SUBJECT: Case H00213: Substantial Alteration to Sacred Heart School, 5820
Spring Garden Road, Halifax

Application by Lyndon Lynch, Architects, on behalf of Sacred Heart School, requesting approval of revised plans for an addition which was previously approved by Council on September 11, 2007, to a registered heritage property at 5820 Spring Garden Road (Sacred Heart School), Halifax.

SUBJECT: Case H00213: Substantial Alteration to Sacred Heart School

MAP 2
Proposed Addition to Sacred Heart School, 5802 Spring Garden Road

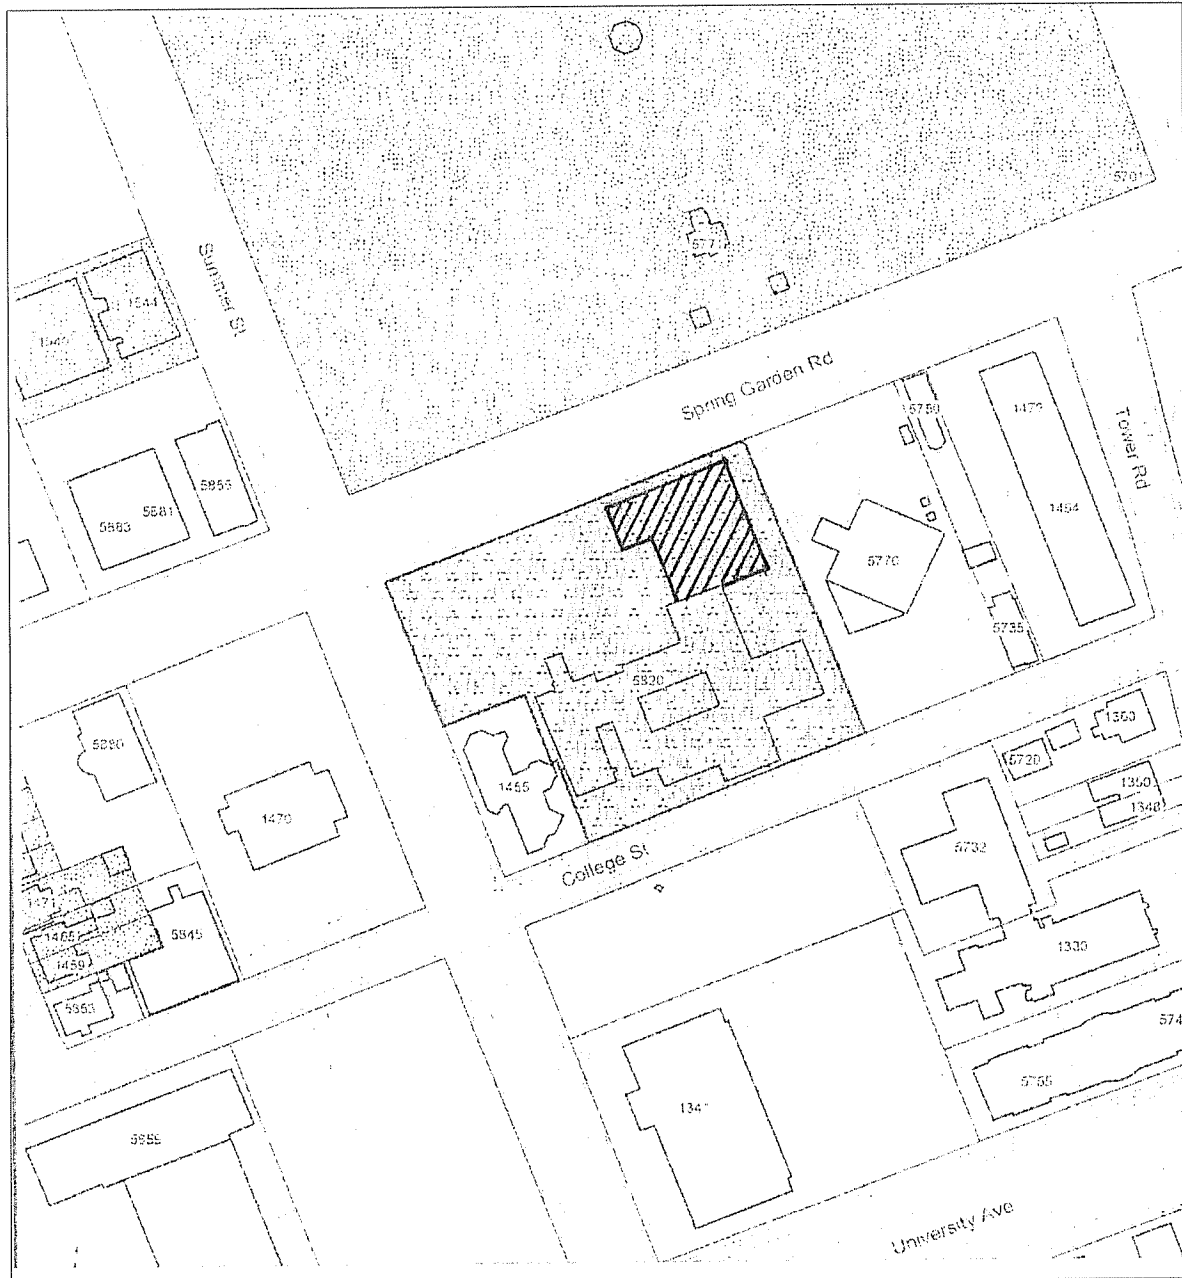
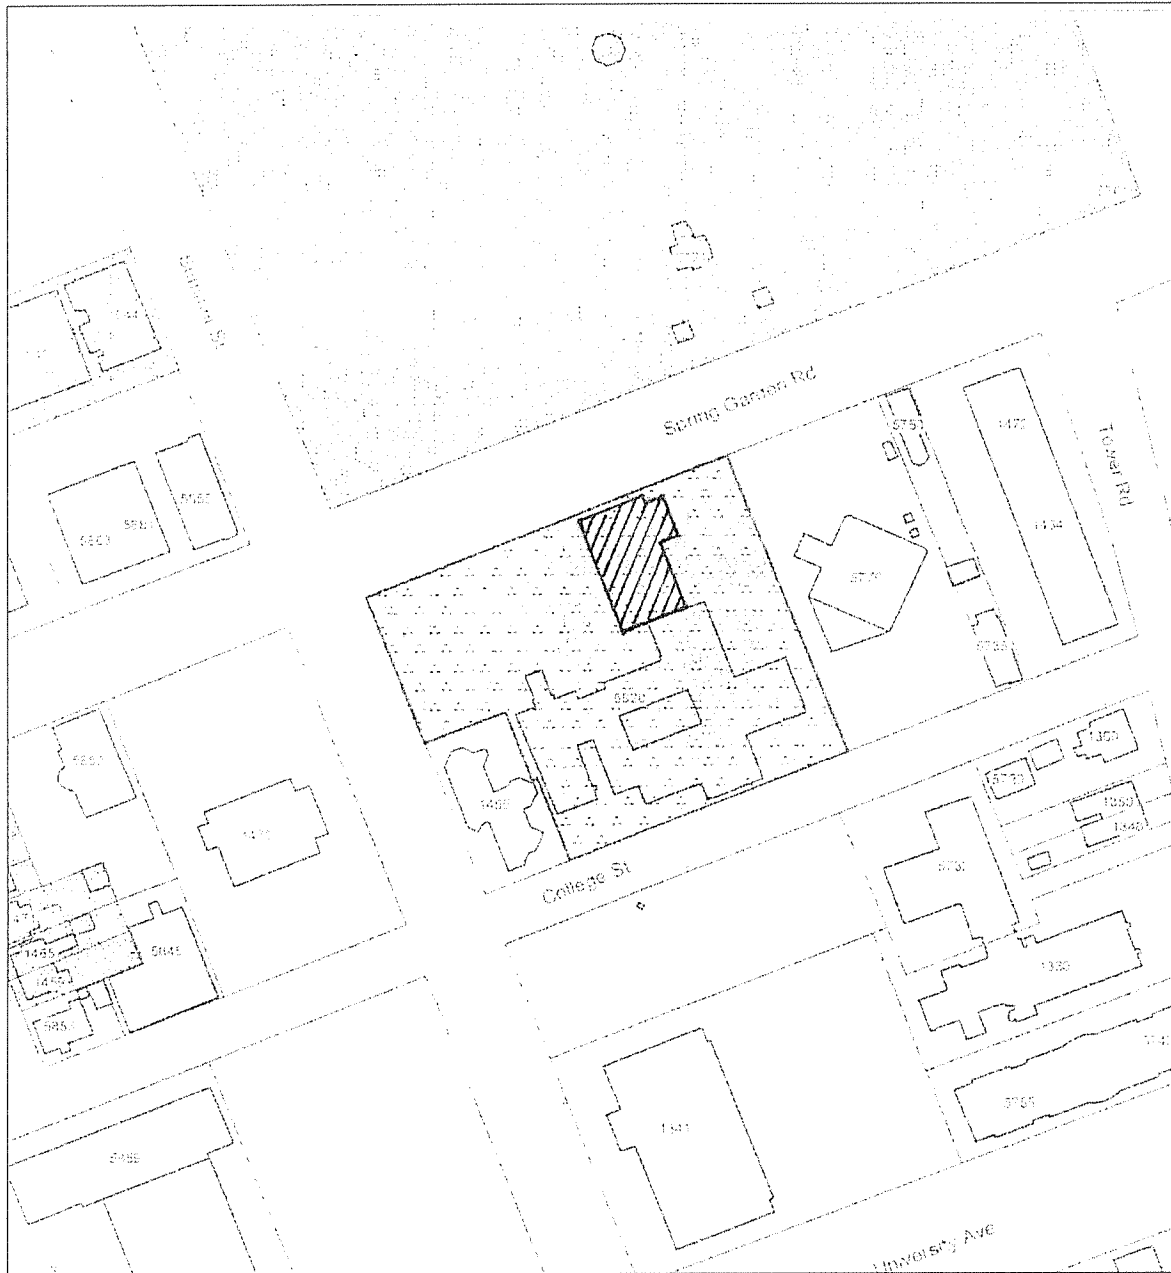
- The building would have a smaller footprint than the earlier design (119' x 59' vs 136' x 120') but greater height, due to the addition of the gymnasium roof.

Additionally, the new design retains more open space around the building than did the earlier proposal by leaving the much of the existing playground intact. The reduction of building footprint

also allows more of the historic east wing to be viewed from the street when approached from the east along Spring Garden Road.

Revised Design, December 2007

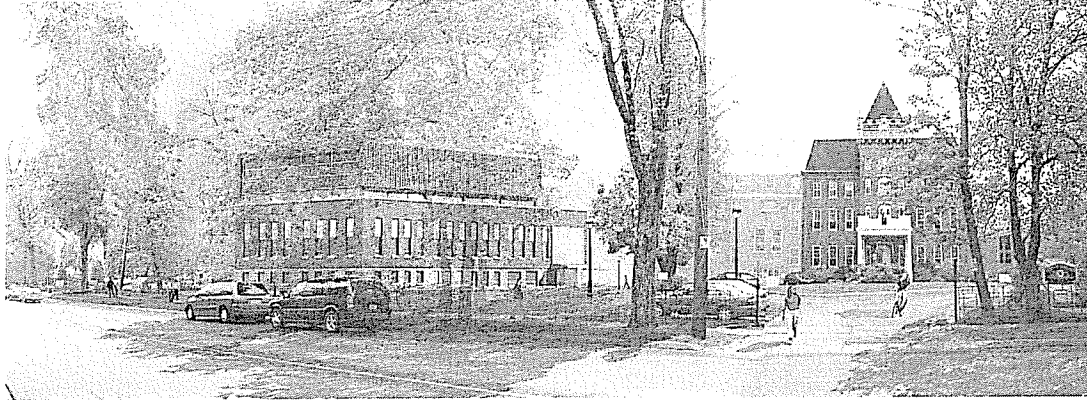
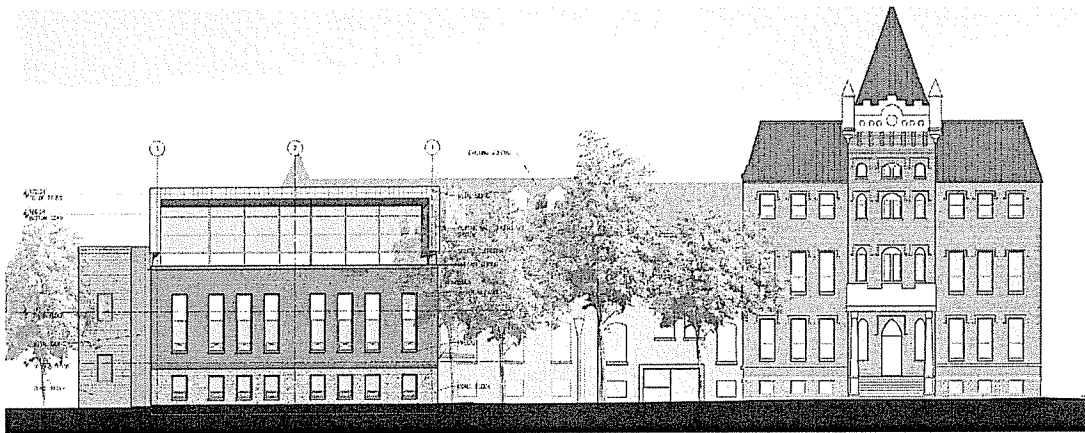
The revised design is different from the earlier design in the following ways:

- The gymnasium would be on the top floor, above the classrooms, under a metal roof with clerestory windows along the east and west sides and a large, open glazed area on the north end facing Spring Garden Road. The roof would be clad in metal siding, light grey in colour.

- Window openings would be taller than in the earlier proposal and would be divided into a lower glazed area (real windows illuminating the second floor classrooms) and an upper solid area filled in with white aluminum panels (roughly corresponding with the gymnasium floor level on the interior).

- The entrance would be located at the south-western corner of the addition and emphasized by a metal panel above the entrance in the same grey metal siding as the gymnasium roof.

Like the earlier proposal, the revised design includes a number of overt references to the traditional architecture of the older, historic sections of the Sacred Heart, including:

- Use of concrete block to define the basement level, echoing the granite foundation on the historic sections.
- Brick cladding on the west and north elevations, reflecting the brick cladding on the historic sections.
- Vertically proportioned window openings, in triplets, similar to those on the historic sections.

At the same time, the addition includes contemporary elements that also echo some elements of the historic section, including:

- white panels above each window, echoing the white stucco portico on the 1851 building.
- a light coloured panel over the entrance, which provides clear definition of the entrance location, similar to the main entrance definition on the 1851 building.

- The gymnasium roof does not mimic the mansard roofs on the historic sections yet has a similar quality to them in terms of its massing. The light grey metal roofing/siding also helps to place the new gym roof in a visually subordinate relationship to the darker, historic mansard roofs.
- On the east elevation, the combination of light grey metal siding, darker grey concrete block, and horizontal fenestration provides an appropriate contrast to the international style, curtain wall design of the existing 1962 addition.

For the above reasons, staff recommend that the revised plans be approved.

East Elevation

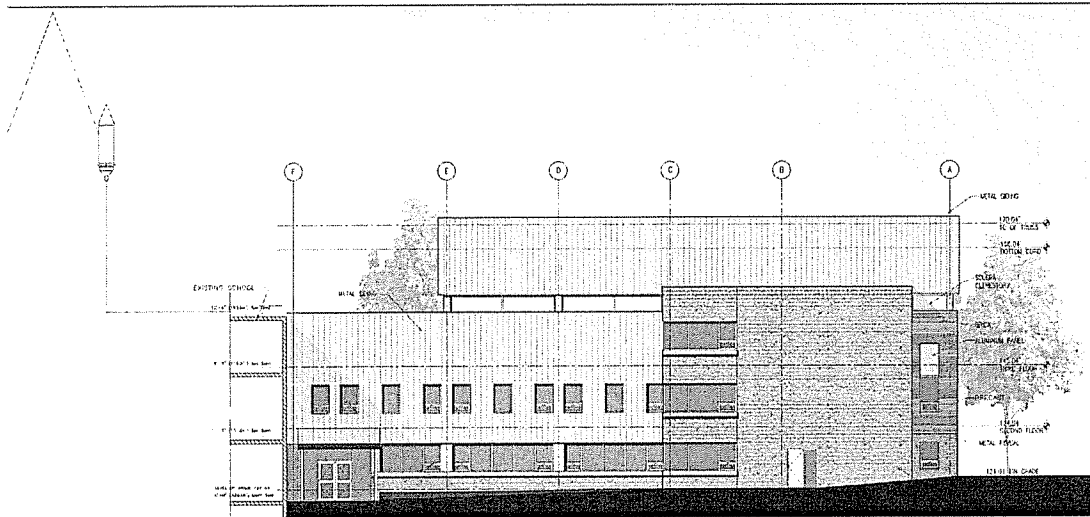
- The basement level would be rendered in concrete block, rather than “shouldice stone”;
- The east side would have a mixture of materials (concrete block and grey metal siding) and a mixture of window types (long, horizontal windows at basement level and punched windows on the second floor).
